City of New York
Parks & Recreation

RE: Application number 7729
94 North 1st Street

Your Parks Site Plan Review is complete. Please find 2 sealed copies of the plan enclosed; one for DOB and one for your records. Please note that having a sealed plan is not a substitute for needing a tree planting permit. It is recommended that prior to the planting season in which trees will be planted the landscaper apply for the planting permits using the P-A Forestry Application. Should you need additional trees to fulfill the zoning requirement please apply for either an off-site location or to pay into the tree fund once the project is in construction. The initial application number must be referenced on all future applications. **If your plans involve any work around any existing trees or tree removals, you must apply for a permit with the Boro Forestry office immediately.** If you have further questions, please contact this office.

PROJECT TITLE:
SITE PLAN

1 SITE PLAN

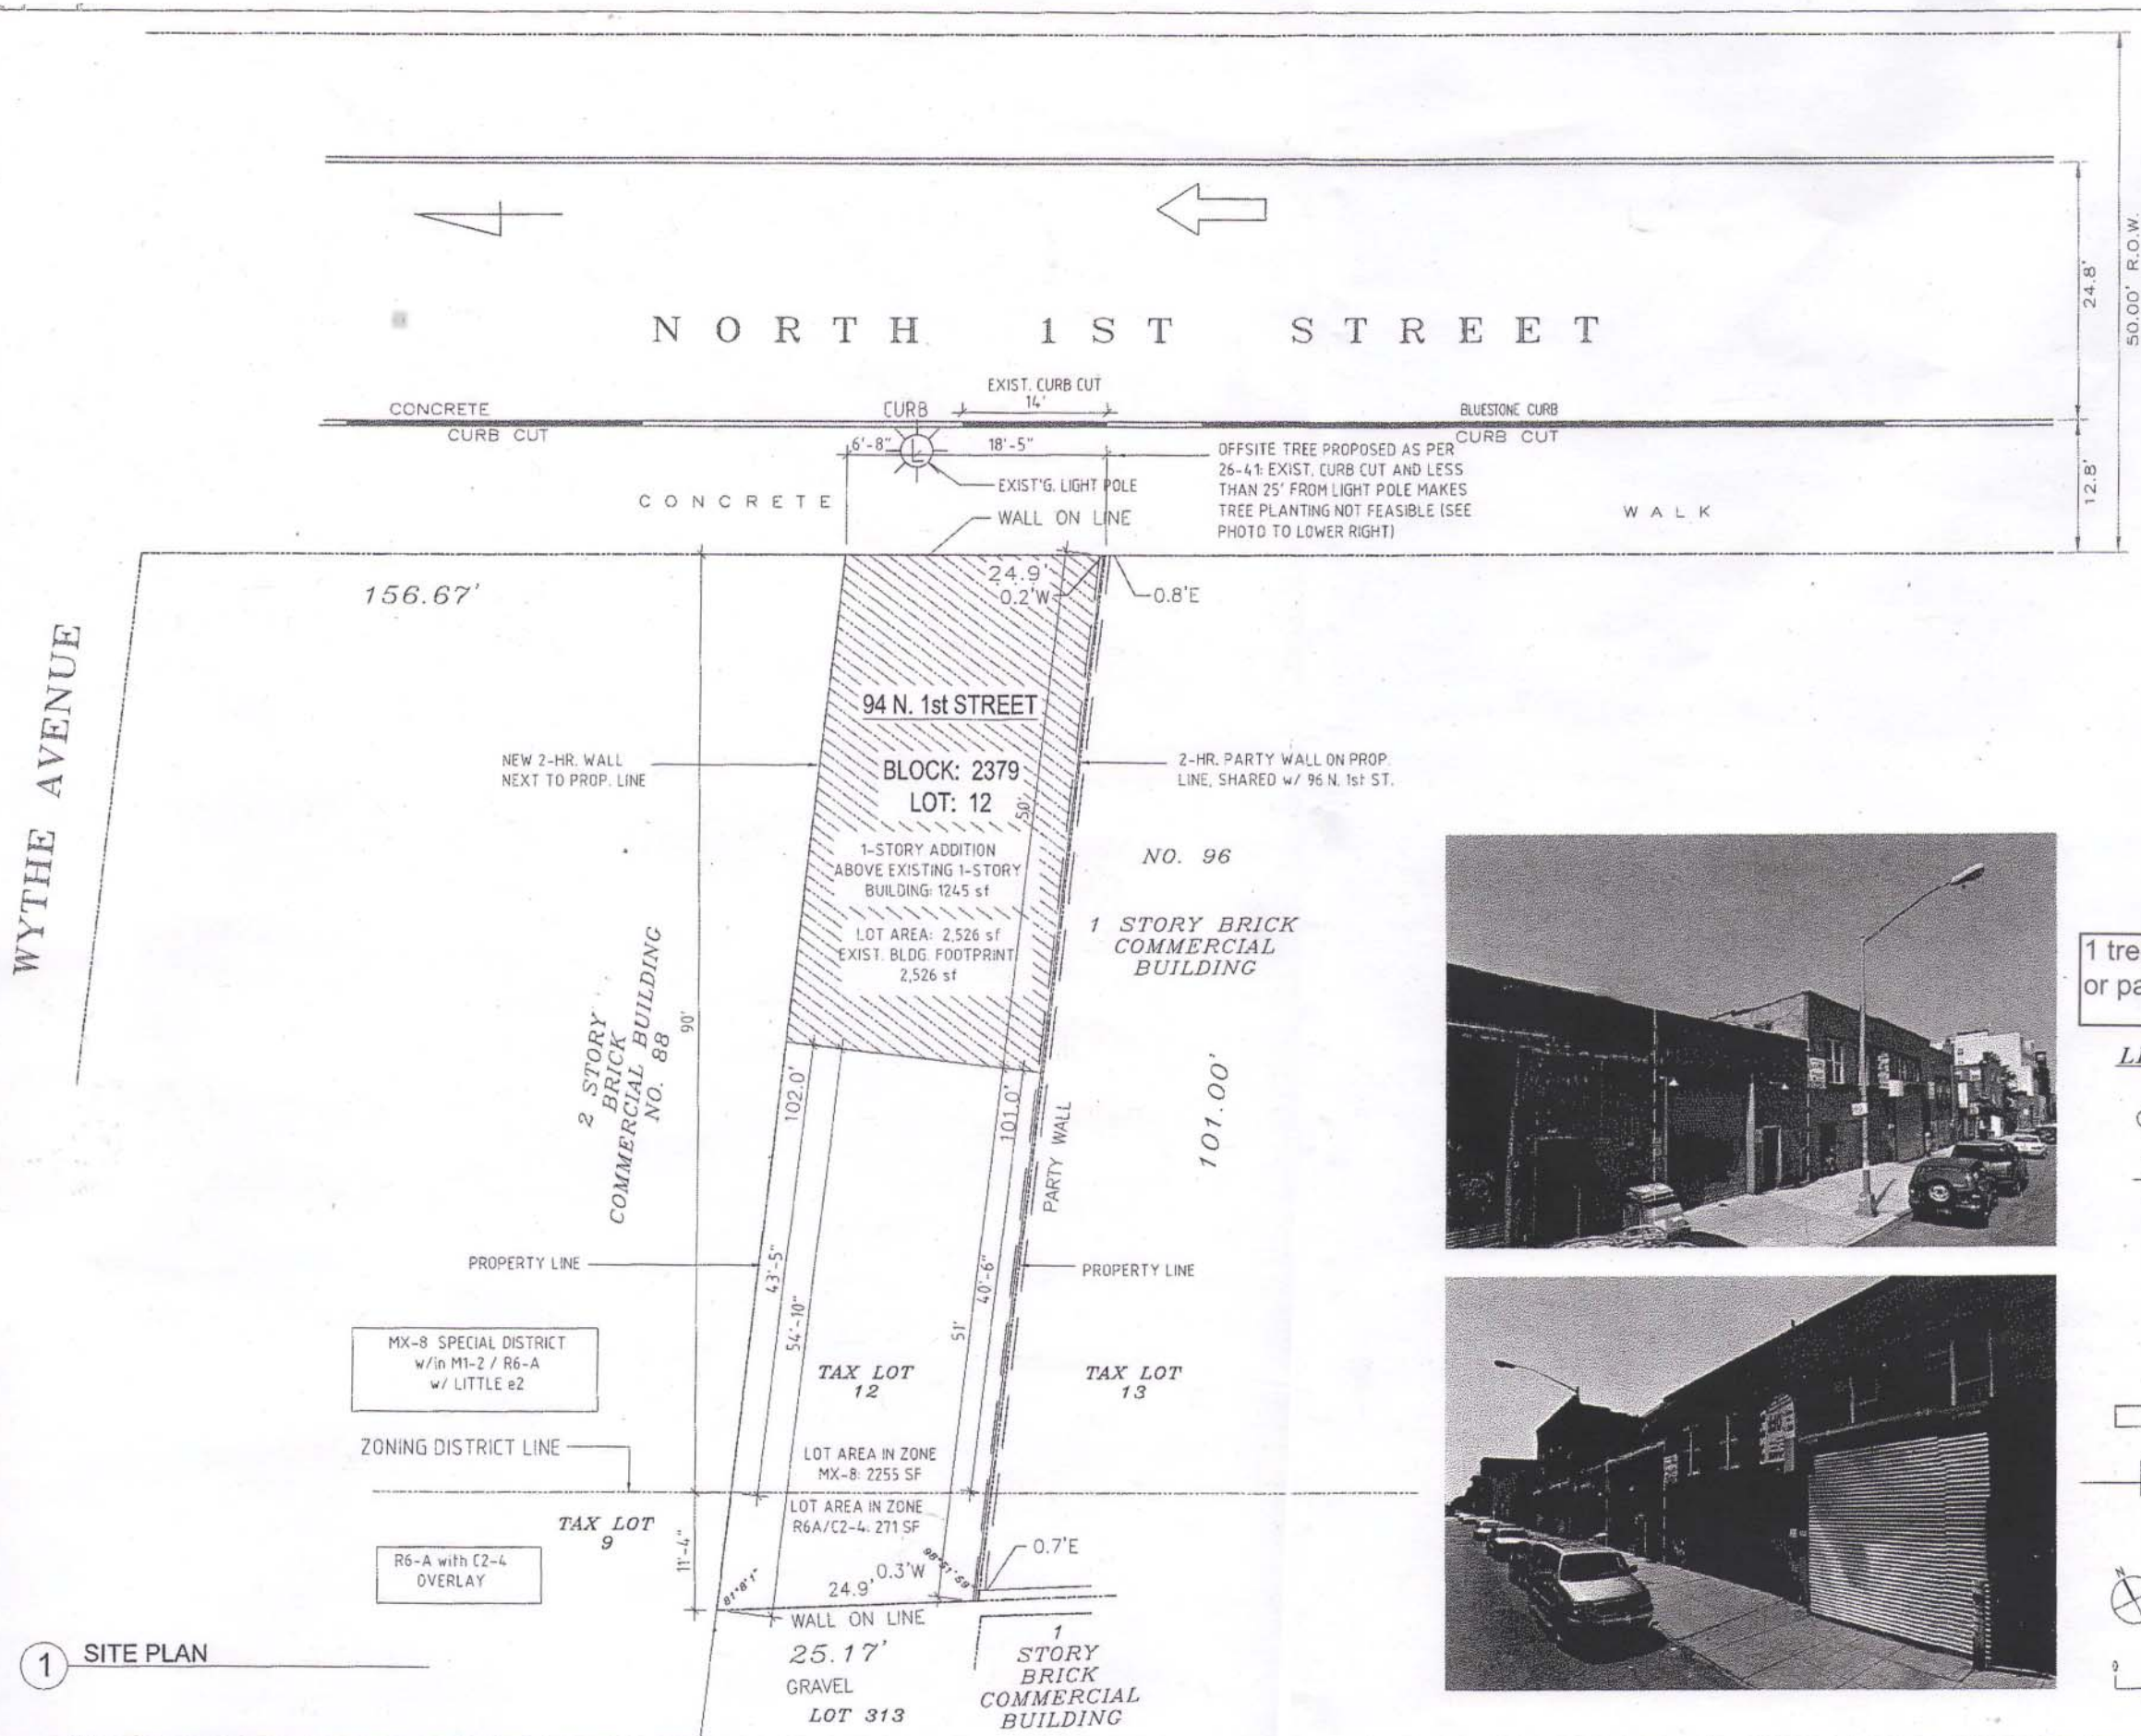
1 tree to be planted offsite or paid into tree fund.
